STONE & WEBSTER ENGINEERING CORPORATION
NINE MILE POINT NUCLEAR STATION - UNIT 2
NIAGARA MOHAWK POWER CORPORATION
J.O. 13177

MANUFACTURER'S DRAWING DATA FORM

MFR'S. DWG. NO. (C) (LIMIT TO 24 CHARACTERS & BLANKS) (37-60): 807E153JY, SH. 3, REV 3

FUNCTIONAL TITLE (E1) (LIMIT TO 48 CHARACTERS & BLANKS) (37-80): NUCLEAR BOILER PROCESS INST ~~&~~ ELEM DIAG

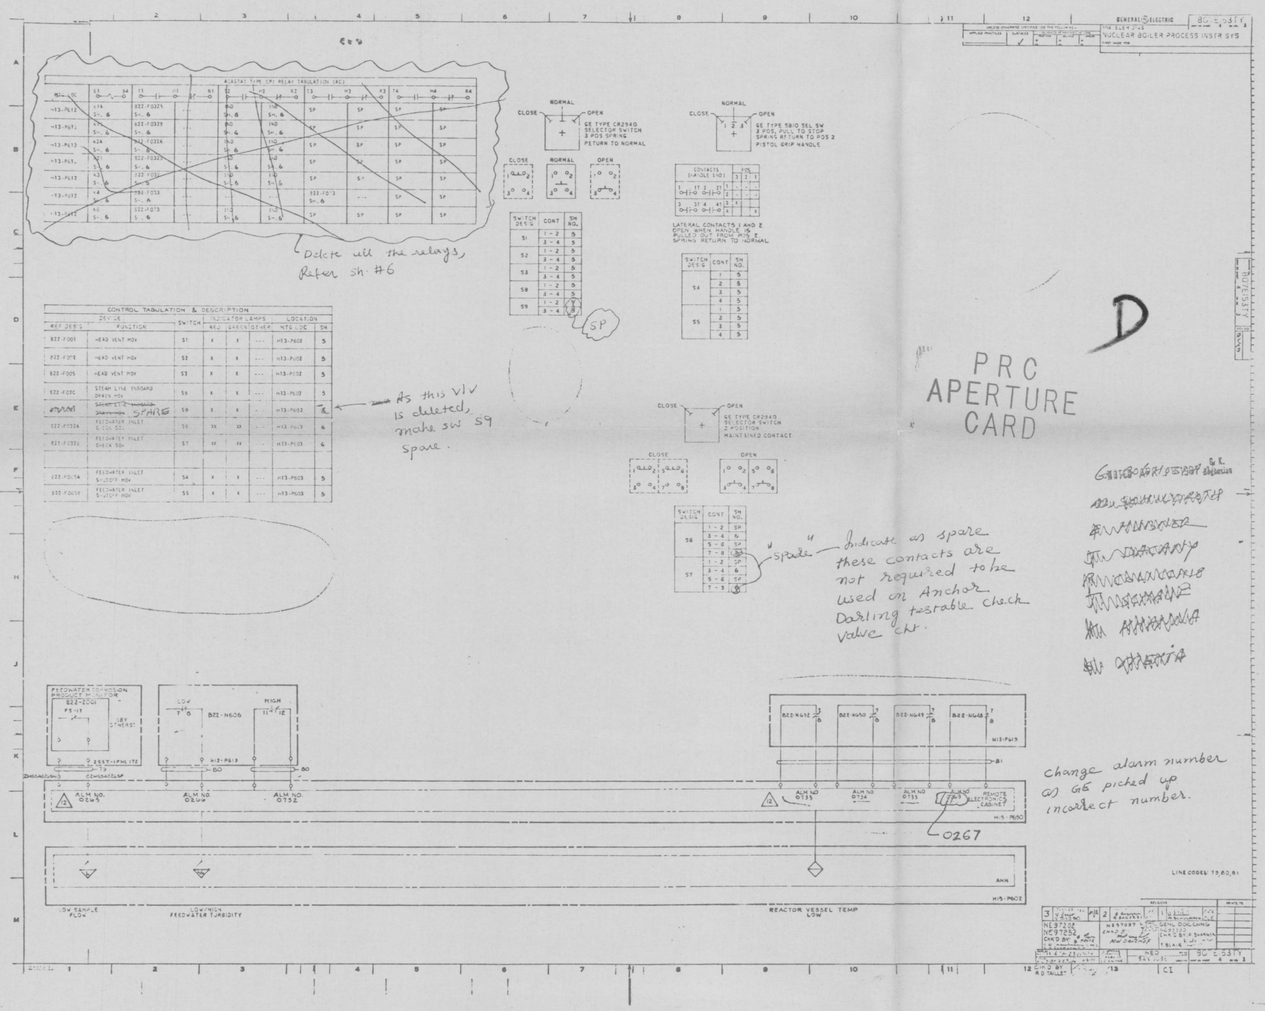
Delete all the relays, Refer Sh. #6

As this V/V is deleted, make SW 59 spare.

Indicate as spare these contacts are not required to be used on Anchor Darling testable check valve ckt.

change alarm number as G6 picked up incorrect number.
